## 200x50 SPREADLEVER BRAKE, AUTO-REVERSE

As part of our continual improvement programme the brake shoe and automatic reverse carrier has undergone a design change. This will be a transitional change in order to standardise production on the brake shoe assembly that can be used with or without the automatic adjustment (ANS) option.

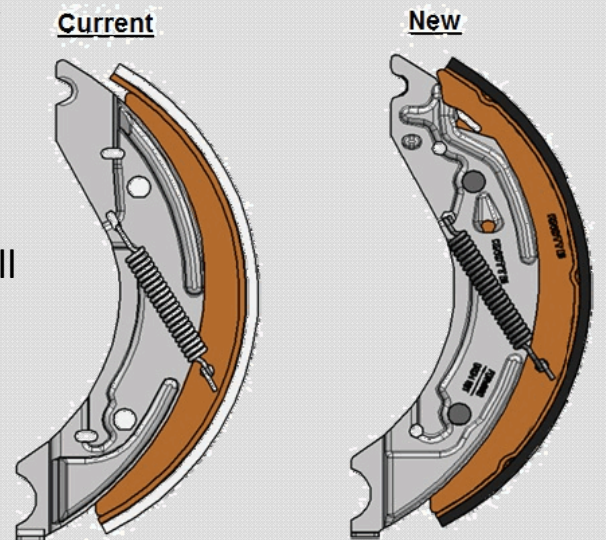
- The **current** complete brake shoe assembly comprises:-

Brake shoe 25692.01  
& brake shoe carrier 35459.

- The **new** complete brake shoe assembly will comprise:-

Brake shoe 411272.001  
& brake shoe carrier 411103.001.

The change will not affect fit or function and is fully compatible with existing spreadlever brakes and backplates.

The existing spring kits are also compatible with the new design brake shoe assembly.
